Appendix D: Esther Bennett (Buddle Findlay) emails

Subject: Eastern Bays Shared Path - follow-up actions to meeting of 9 November 2020 [BUD-LIVE.FID762079]

Project: Eastern Bays Shared Path

Oystercatcher protection area: Sorrento Bay

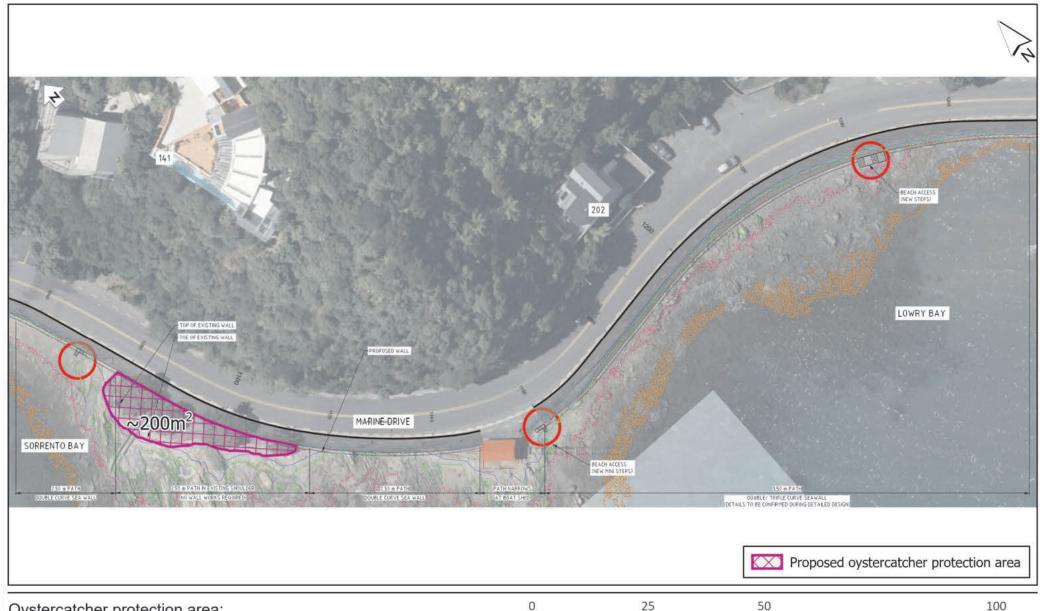
- The map for a new oystercatcher protection area in Sorrento Bay, which is proposed in addition to the other three penguin and shorebird protection areas – this has arisen out of a discussion we had with John Cockrem earlier in the week and this will be incorporated into condition EM.1B and the other conditions as needed
- 2. The three maps for the penguin and shorebird protection areas in Whiorau Reserve, North of Bishops Park and HW Shortt Park these are the same as the ones provided on Friday, I only attach them again for ease of reference
- 3. An updated protection area overview, which shows the four protection areas; and
- 4. The map for the oystercatcher managed works zone in Sorrento Bay, which relates to proposed condition EM1C(c) below.
